### **REMARKS**

**"VERSION WITH MARKINGS SHOWING CHANGES MADE"**

**IN THE DRAWINGS**

Fig. 13

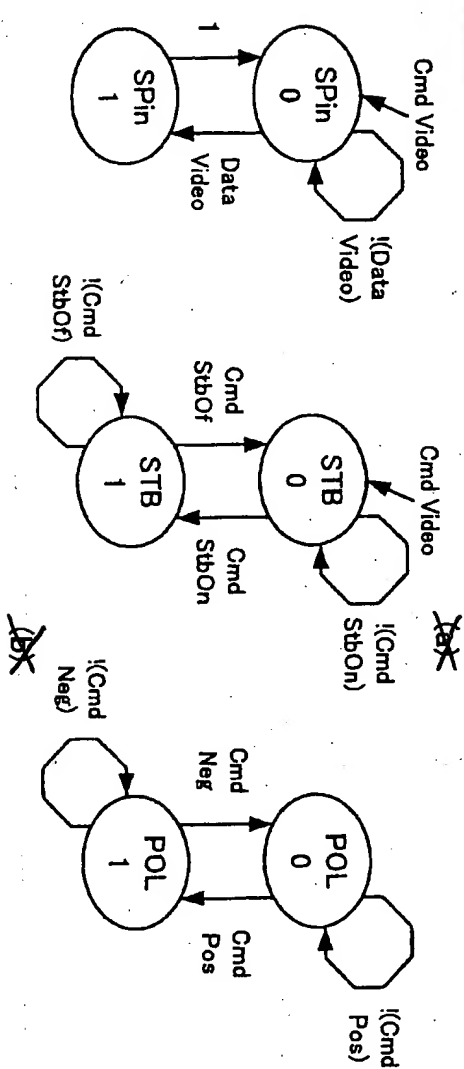
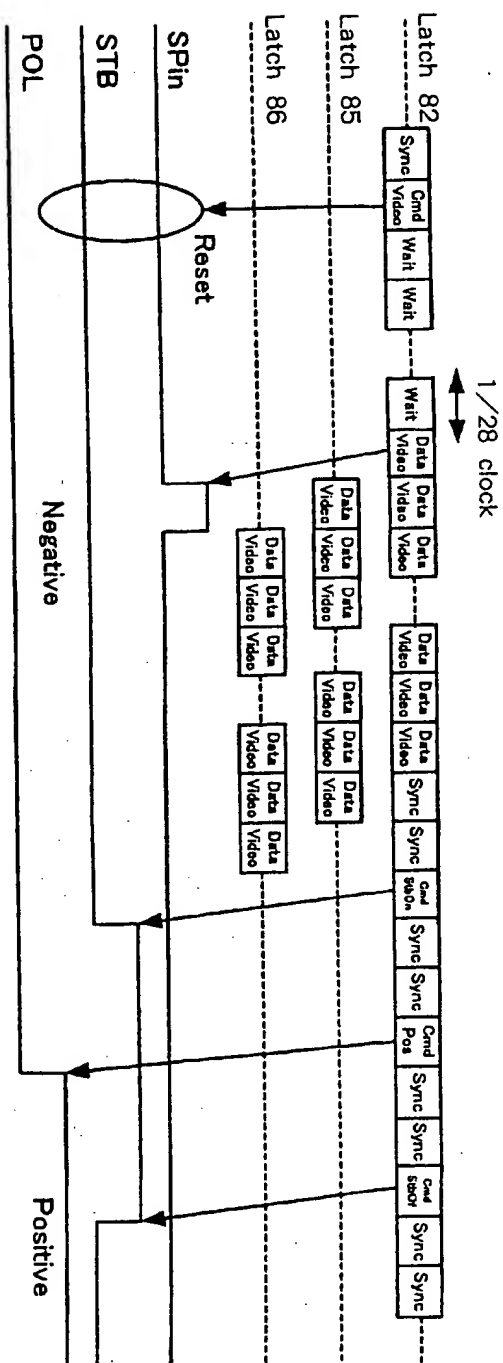
With regard to the drawings, Applicants herein request that Figure 20 be labeled "Prior art," and that Figure 13 be amended to show "(a)" and "(b)" in the appropriate locations. The changes to Figures 13 and 20 are shown in the sketches submitted herewith. In view of these changes to Figures 13 and 20, the Examiner is asked to reconsider and to withdraw the objections to the drawings.

Drawing Figures 13 and 20 have been amended marked in red ink.
